Review of Walking and Cycling Connections to/from the proposed Foundry Lea Development

October 2021

Bridport Town Council commissioned Streets Reimagined and Highgate Transportation to consider strategic opportunities for improving walking and cycling connections to/from the proposed Foundry Lea development. The commission also included a review of the current proposals for walking and cycling infrastructure within the development as set out in the Draft Design and Access Statement (June 2021).

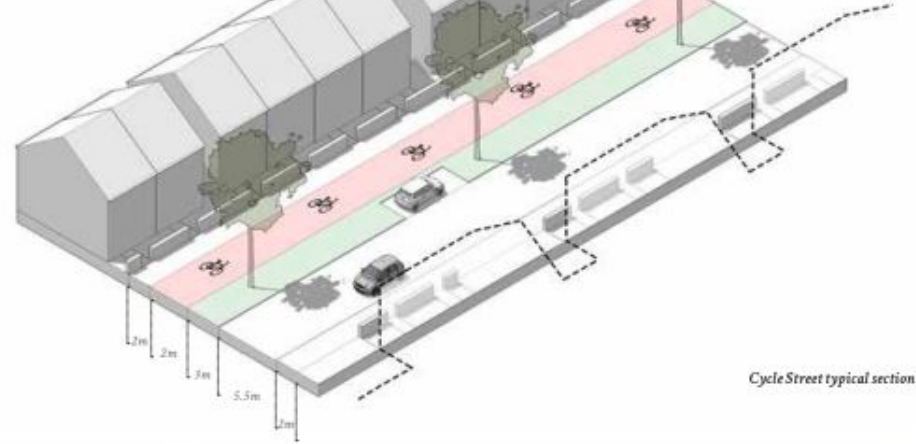
- There is currently only one segregated cycle route proposed in the design code (referred to as a 'Cycle Street') but if cycling is to be considered a commuting mode of transport, then consideration should be given to creating a network of segregated routes that provides safe access throughout the site and beyond
- There could be more provision for the use and storage of cargo bikes (e.g at local centre and within residential streets) to enable cycling to become a viable mode of transport for more people
- There is potential for further cycling connectivity with the wider town i.e. from the west, south and southeast of the site through to the eastern boundary for town centre access

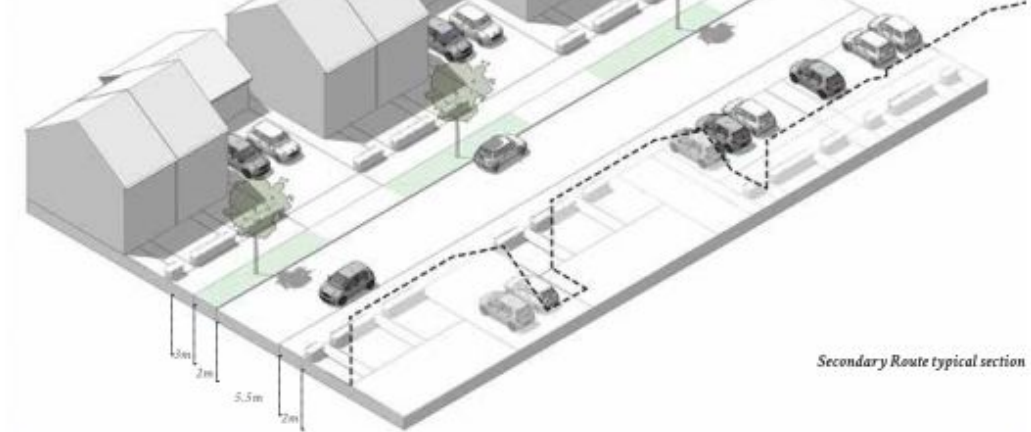
Shared footway and cycle paths are proposed in a number of locations which are contrary to current best practice*

Brit Bridge: Bike/Cargo bike swept path analysis

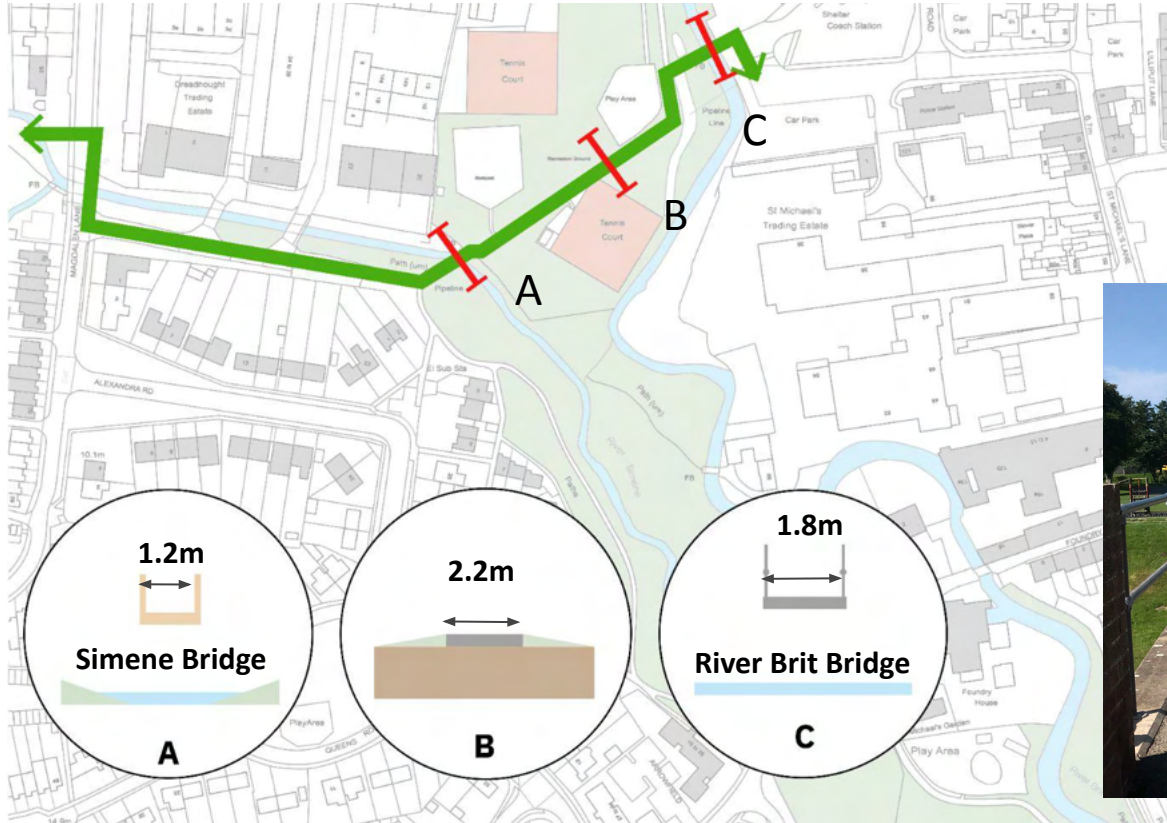
Insufficient width to meet national guidance

- Currently insufficient width for bi-directional shared walking and cycling use on Brit Bridge
- Eastern ramp, with sharp 90 degree bend is unsuitable

2-way cycle track	For a >300 peak hour cycle flow track, the desirable width minimum is 3m (LTN 1/20 p.43)
Pedestrian footway	Minimum of 2m is required (Manual For Streets p.68)
Parallel crossing	Provide a legal priority to pedestrians and cyclists. The parallel crossing is similar in form and application to a zebra crossing, but with a separate parallel cycle crossing alongside the zebra crossing (LTN 1/20 p.101)
Fully kerbed cycle tracks	Fully kerbed cycle tracks may be set at carriageway level, at footway level or at an intermediate height between the two (LTN 1/20 p.52)
Bridge width	Overall desirable minimum widths between walls/parapets is a 5.5m separate provision (2m footway, 3m cycle track, 0.5m clearance on one side) (LTN 1/20 p.128)

Required bridge dimensions (to meet national guidance)

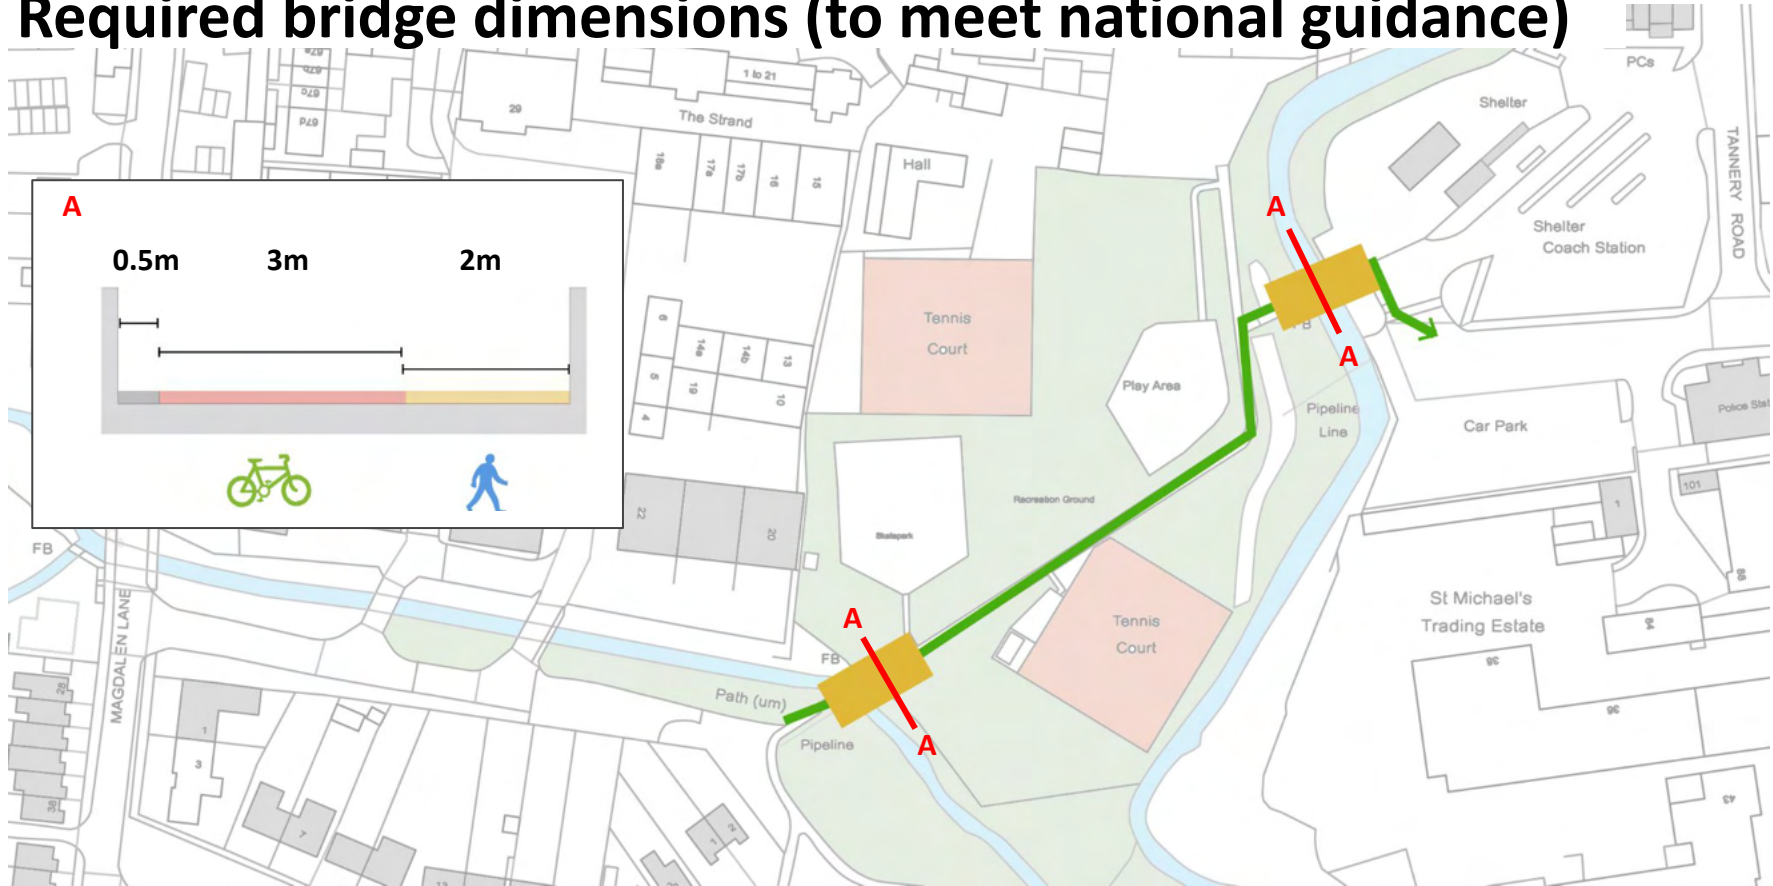
New bridges would be required at River Simene and Brit
